# IAI WESTWIND

## SERVICE BULLETIN

1124 SERVICE BULLETIN INDEX

FIGURE 1

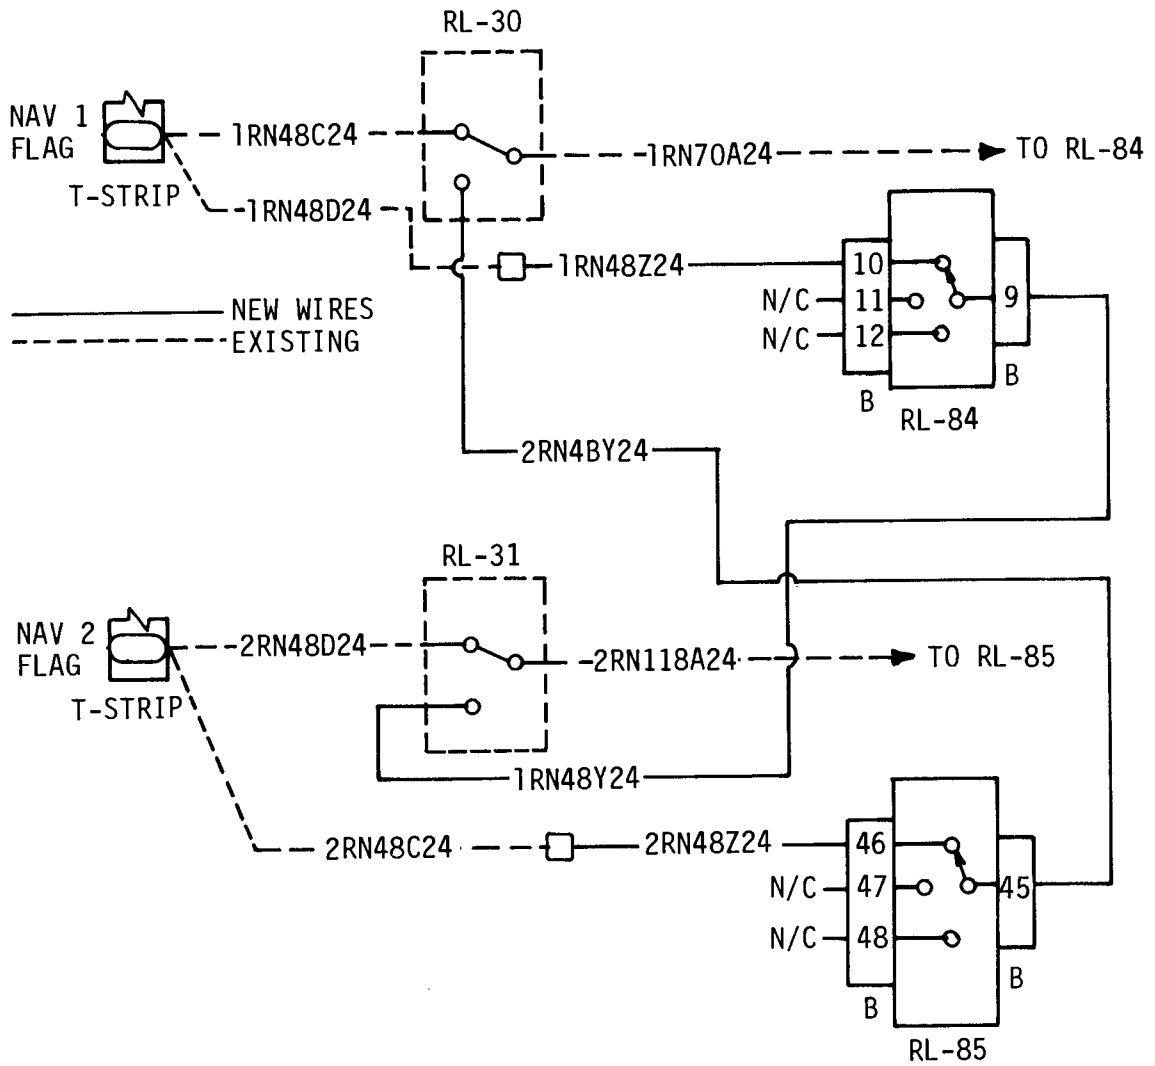
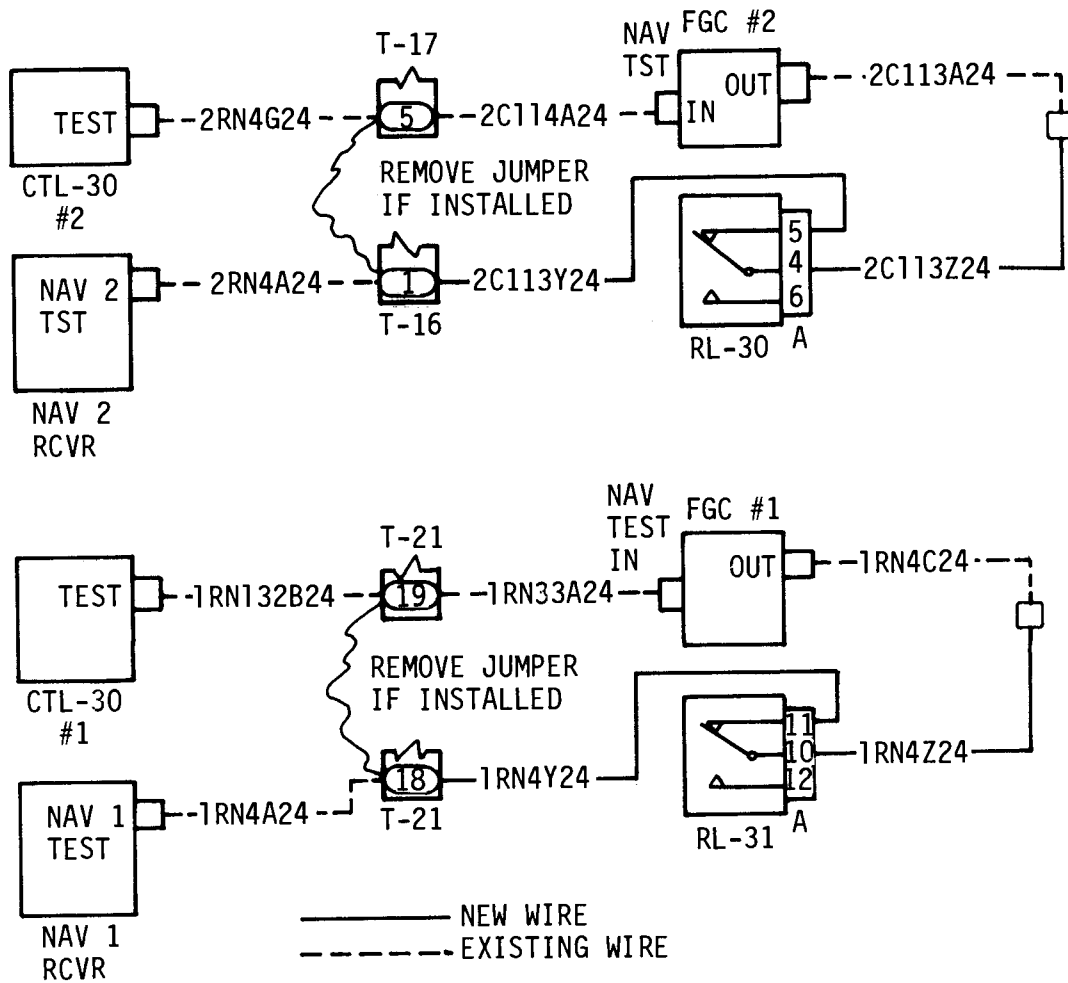
- B. Conformity with the above tests indicates compliance and no further action is required. Unsatisfactory results will require modification in accordance with the remaining steps (reference Figure 1).

- (2) At copilot position, select "RPT NAV 1" and attempt VIR-30A self-test on #1 NAV CTL-30. Restore Copilot HSI to Normal VOR/LOC.
- B. Self-test in Step A must be inoperative, conformity indicates compliance and no further action is required. Should self-test be operational, modify in accordance with the following steps (reference Figure 2).

- H. Add new wire 3C113Y24 from RL30A-5 to T16-1.
- I. Repeat Step A for test and inspection.

FIGURE 1: VERTICAL GYRO INSTALLATION.  
-RE 1: Single Instl  
-RE 3: Dual Instl. (1 of 2)

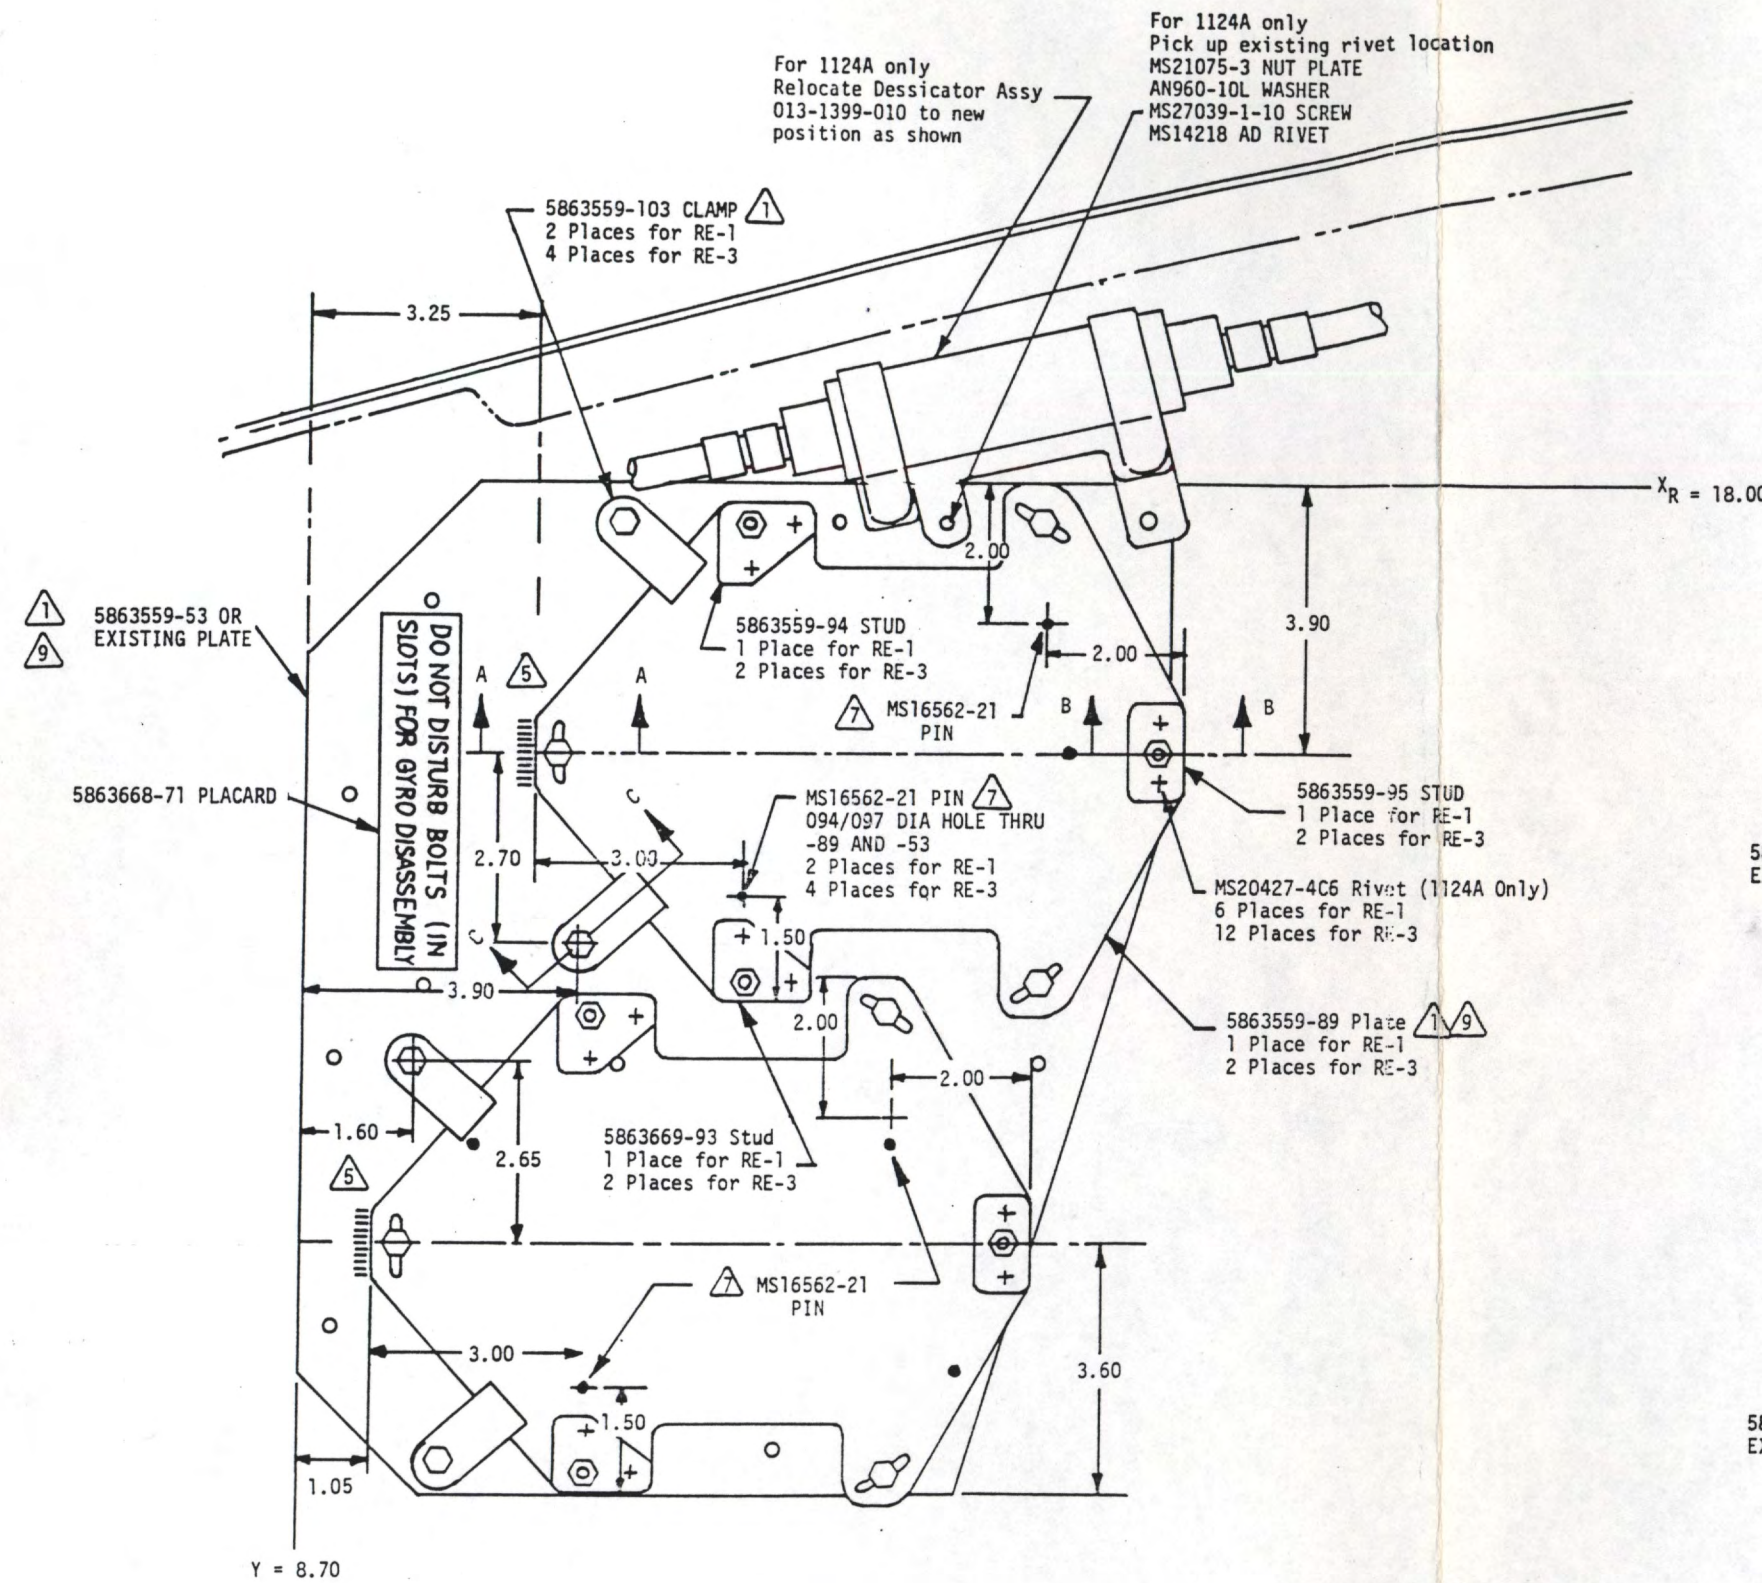
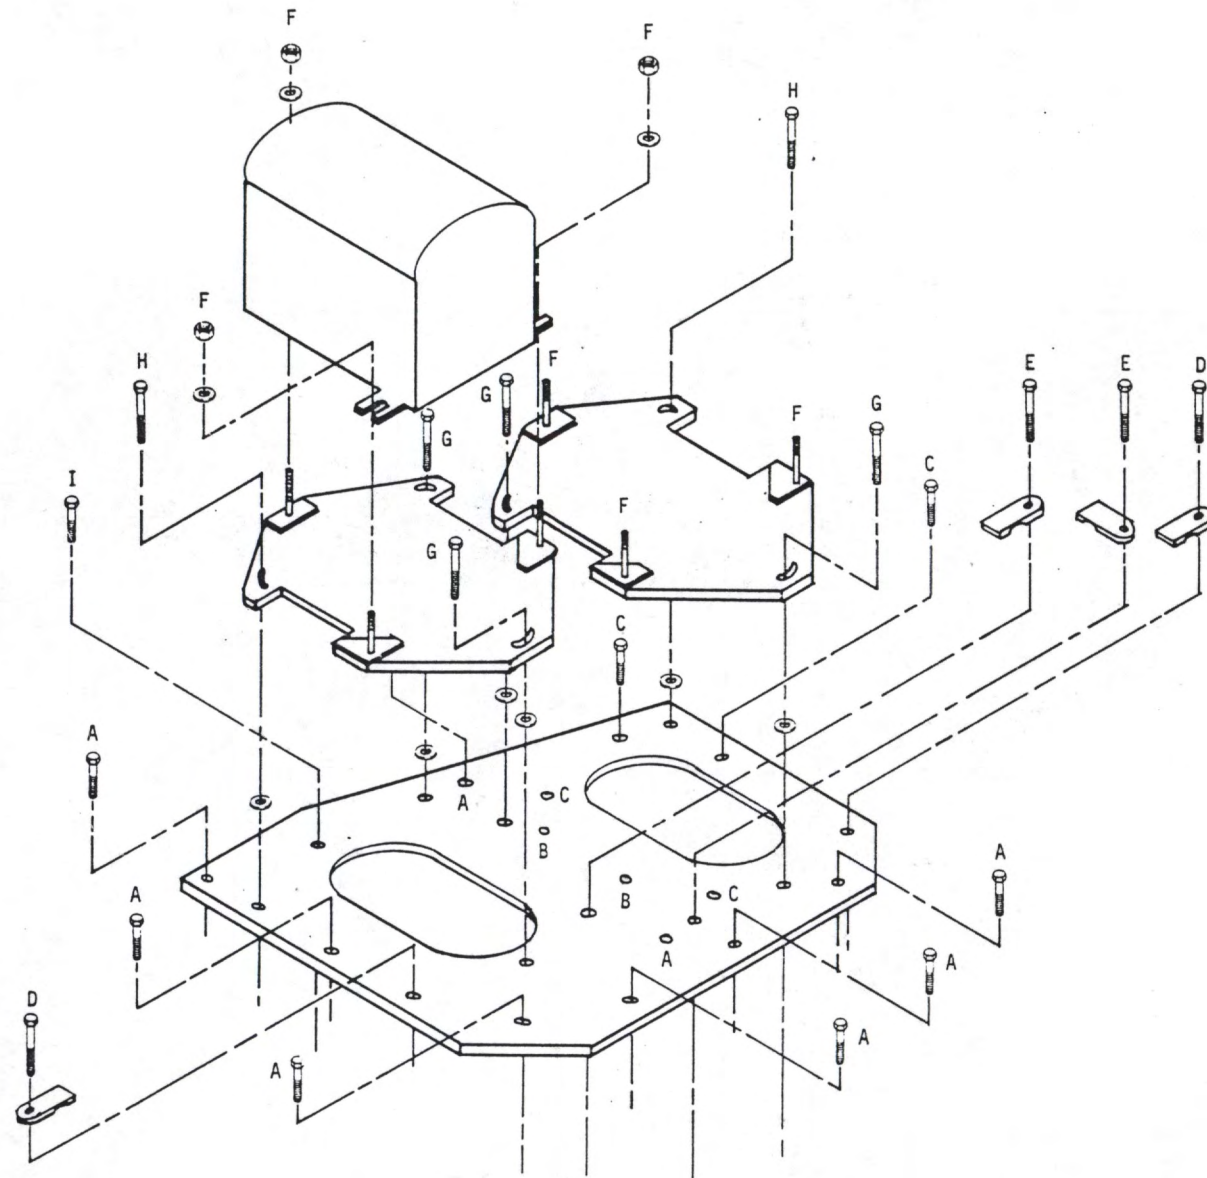
- E. Install P/N 5 863559-53 base-plate, P/N 5 863559-89 skew-plate assembly(s) and P/N 5 863559-103 clamps per Figure 1. Install nut-plates through oxygen bottle access cover or nose deck structure only (not through P/N 5 863559-53 base-plate) using MS14218AD rivets.

If skew-plate(s) are 1/8 inch in thickness, drill out rivets securing the three stud assemblies per plate and replace them with one each P/N 5 863559-93, 94, 95 per skew-plate using MS20427-4C6 rivets (Figure 1).

- F. Lay out and install P/N MS21075-3 nut-plates per Figure 1 using MS14218AD rivets. Install all nut-plates on bottom of nose deck structure and bottom of oxygen bottle access cover (not on P/N 5 863559-53 base-plate).

- G. Install oxygen bottle access cover base, plate P/N 5 863559-53, skew-plate(s) P/N 5 863559-89, and clamps P/N 5 863559-103. Refer to Figure 1 for hardware information as well as which base-plate holes require countersinking.

- H. Relocate desiccator assembly per Figure 1.
- I. Reinstall gyro(s) and level per Service Information Letter No. 1124-22-038 "Vertical Gyro Adjustment Procedure." Leveling can be accomplished by adding AN960-PD10L washers under the gyro mounts (Figure 1, Section B-B). Grind washer faces as required to achieve proper thickness.

Figure 1 of 3

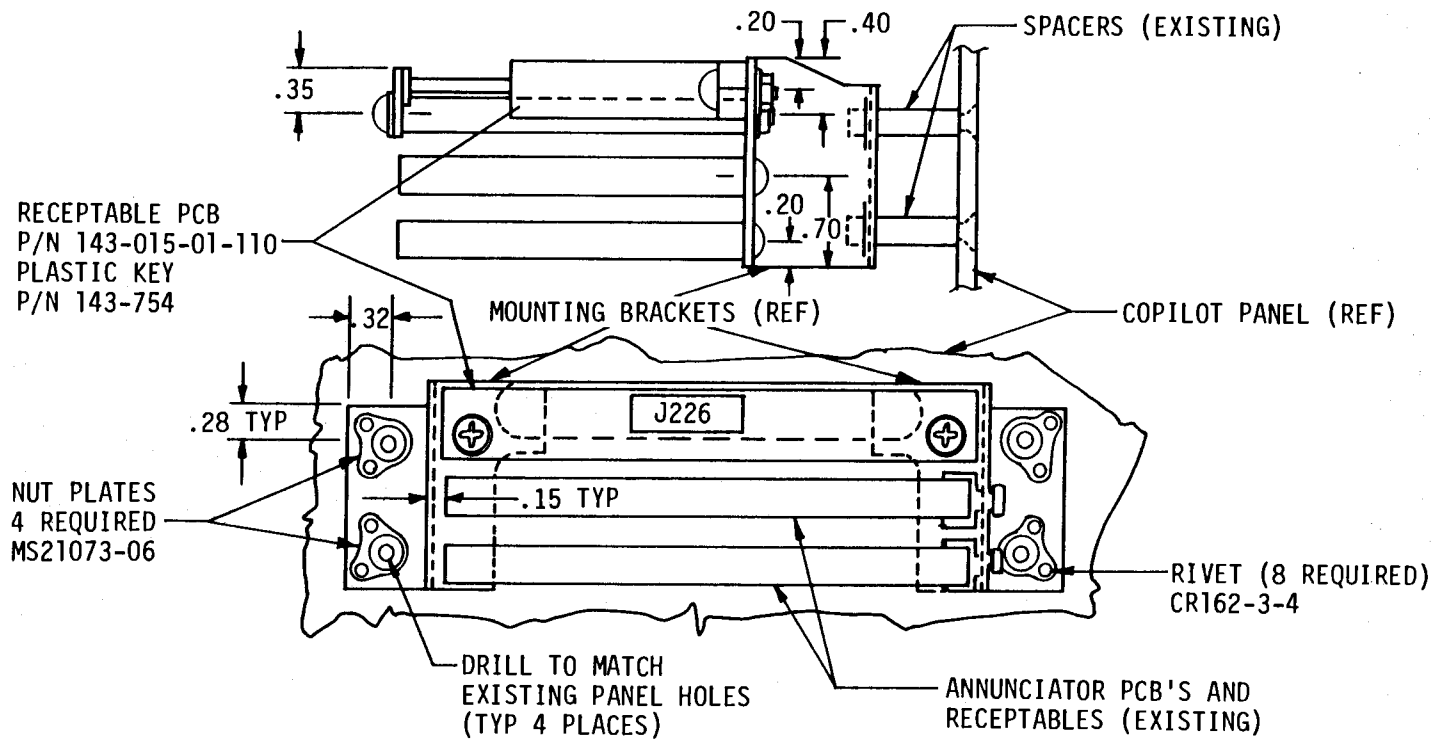
- (3) Remove existing diode board mounting brackets from stand-offs and discard brackets (retain hardware for following steps). Refer to Figure 1.
  - (a) Use brackets P/N 5883775-RE3 and 5883775-RE4 or locally fabricate new mounting brackets from standard and 10139-070-1 stock ALCLAD 2024-T3511 (two required - second (5883775-RE4) bracket opposite of Figure 1 view).

- (b) Use bracket P/N 5883775-RE5 or locally fabricate hold-down strap from .063 ALCLAD 2024-T6 stock per Figure 1.
- (4) Secure new brackets in place on instrument panel using hardware from step (3) above.

- (b) Drill holes in brackets and mount PCB receptacles using Loctite on screw threads. Mount pillars in same manner with screws and spring washers as shown on Figure 1.

Figure 2 of 3

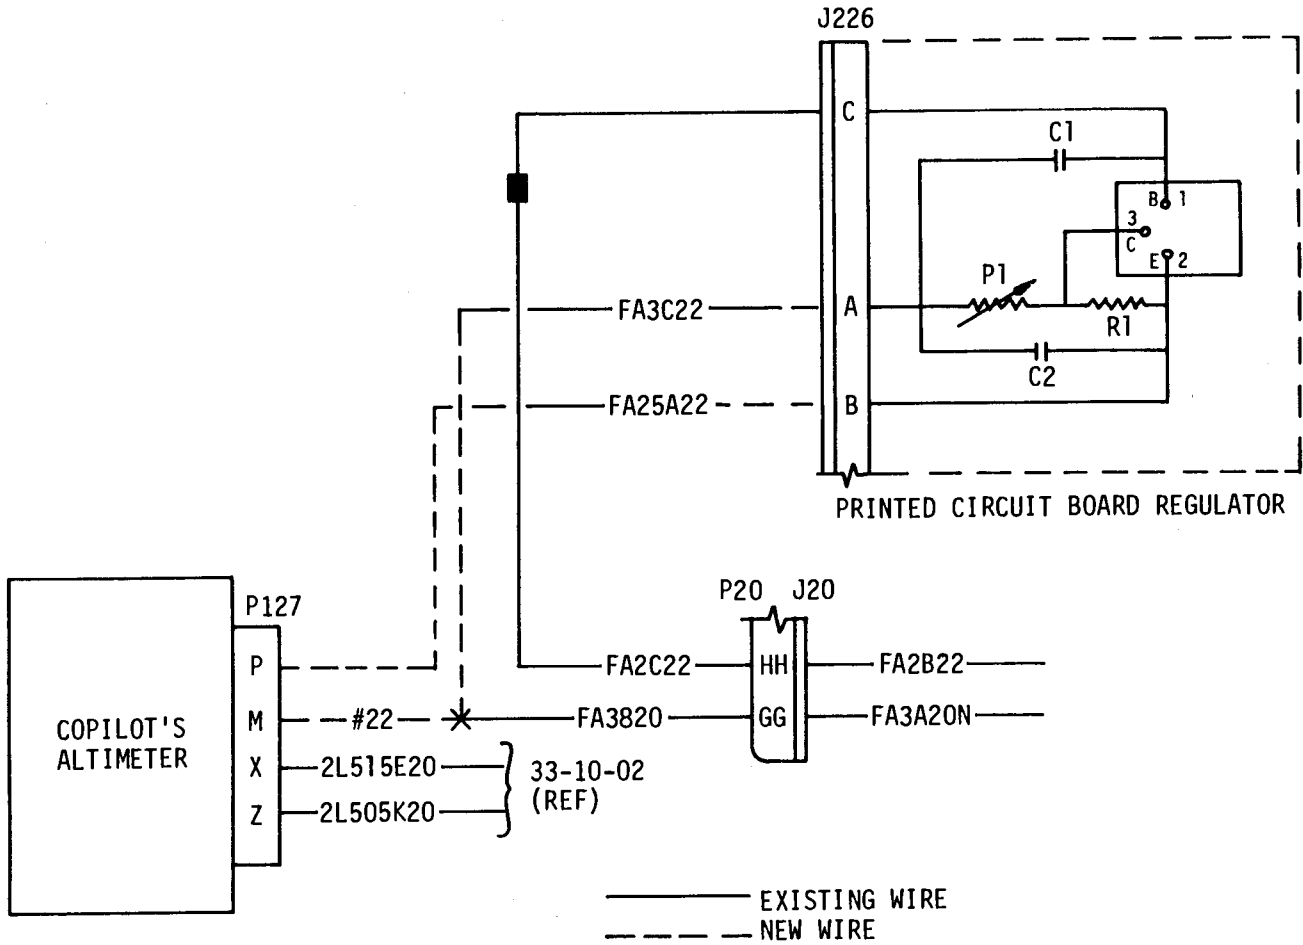
- (a) Align printed circuit board (PCB) receptacles on mounting brackets as per Figure 2 and mark brackets for drilling of mounting holes. Follow same procedure for pillars used for securing regulator board.

VIEW LOOKING OUTB'D R.H.S.  
FIGURE 1

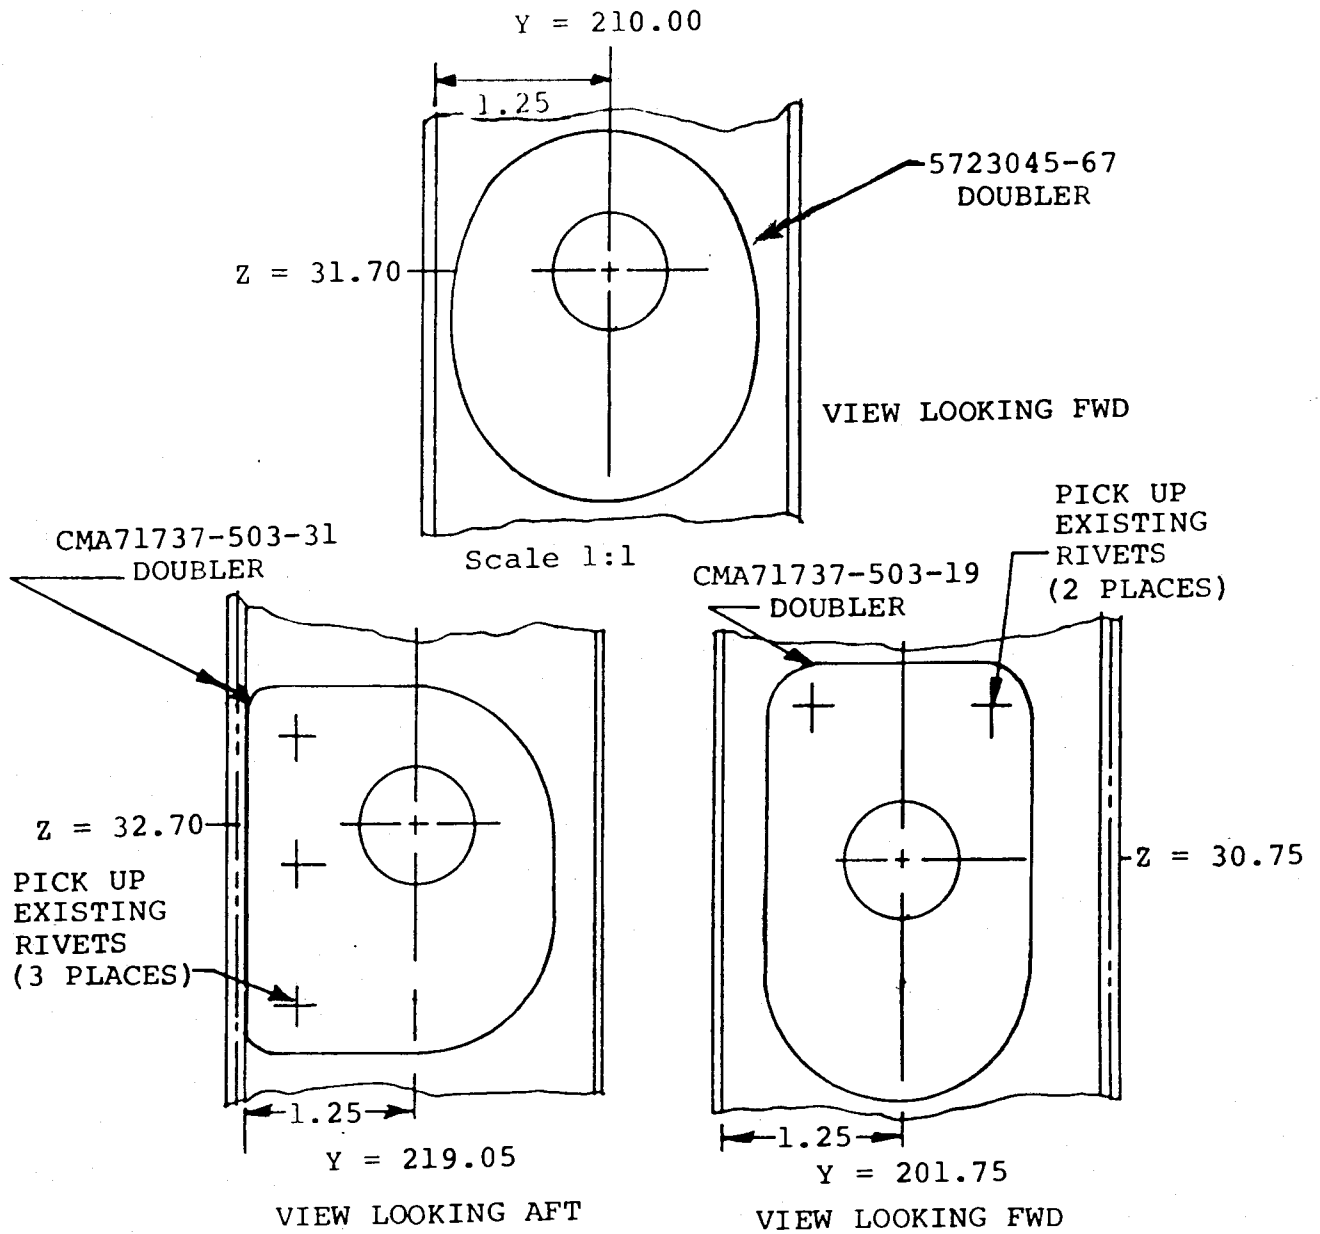
- (1) Disconnect tube at tee fitting adjacent to static port and at elbow fitting between frame Stations 219.05 and 223.75. Refer Figure 1.
- (2) Remove clamps supporting tube and remove tube.
